NOTICE OF DECISION
Liberty Leasing Self-Storage
Permit No. TUM-23-1345
March 1, 2024

RE: Liberty Leasing Self-Storage Formal Site Plan Approval
TUM-23-1345; Construction of a 69,000 sf self-storage facility with 445
storage units
Corner of Old Hwy 99 and 84th Ave SE, Tumwater, WA 98501
Parcel #31100000101; 3.08 acres

FORMAL SITE PLAN

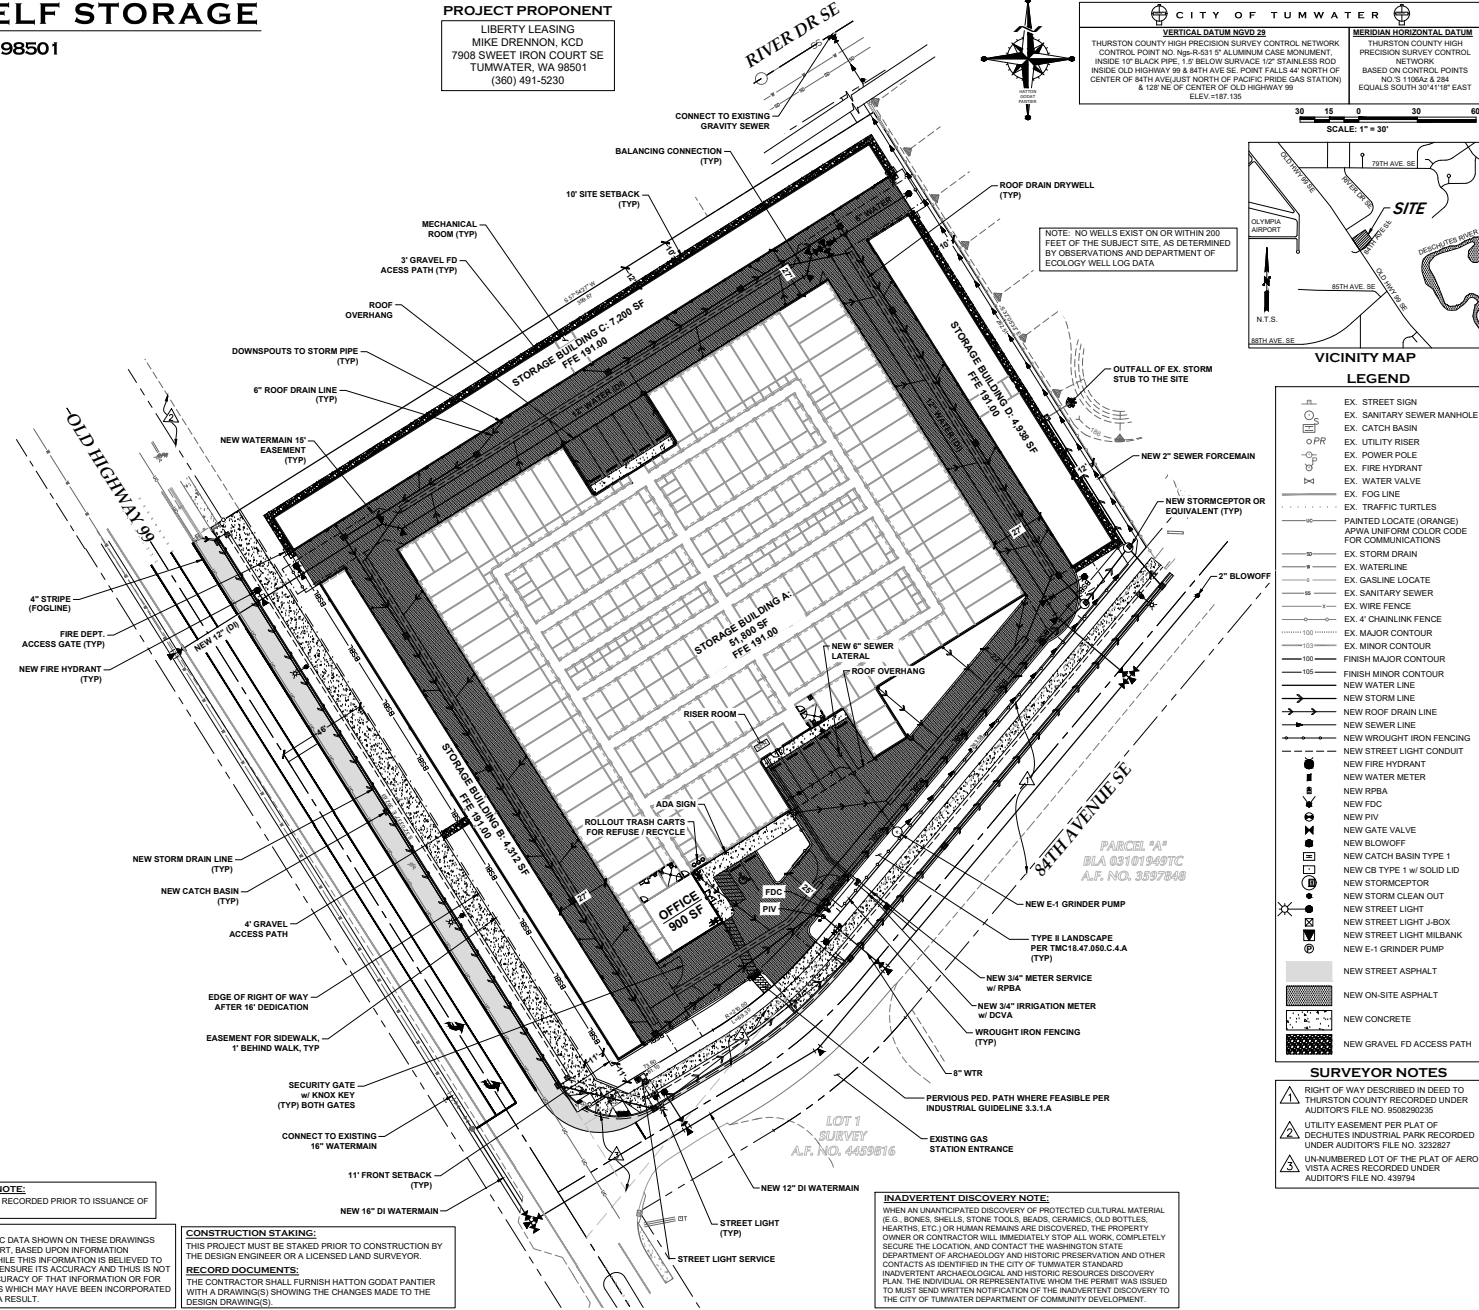
3. Yards/Setbacks: The minimum required setbacks for the LI zone district [TMC 18.24] are as follows:
 - a. Front yard: 20 feet on Old Hwy 99 and 84th Ave
 - b. Side yards: 10 feet minimum

Design guidelines can allow for the front yard setback to be reduced to 11' with approval by the Community Development Director.

Maximum impervious surface for the site is 85%.

4. Parking: The parking proposed on the site meets the requirements for off-street parking. [TMC 18.47]
 - a. Parking stall sizes are as follows:
 - 9' x 18' - Standard stalls
 - 9' x 18' – Barrier-free
 - 16' x 18' - Barrier-free van stalls
 - b. The parking area must be hard-surfaced (asphalt, concrete or turfstone) and the spaces shall be defined by white striping a minimum of 4-inch wide. Parking spaces must utilize approved wheel stops to prevent vehicle overhang of a sidewalk or walkway. The parking aisle (lane) must be a minimum of 22' 6" feet wide. All vehicle maneuvering areas shall be paved.
 - c. Wheel stops shall be used adjacent to landscaped and pedestrian areas.
 - d. Bicycle storage facilities are required for the site and shall meet the requirements of TMC 18.50.120. Based on the proposed parking two short term spaces are required and one long term space is required.

The Community Development Director has approved a change to the front setback as allowed by the Design Guidelines reducing the front setback from 20' to 11'. The setbacks and lot coverage shown on the plan meet the ordinance requirements.

Car and bicycle parking shown on the site plan meet the ordinance requirements.
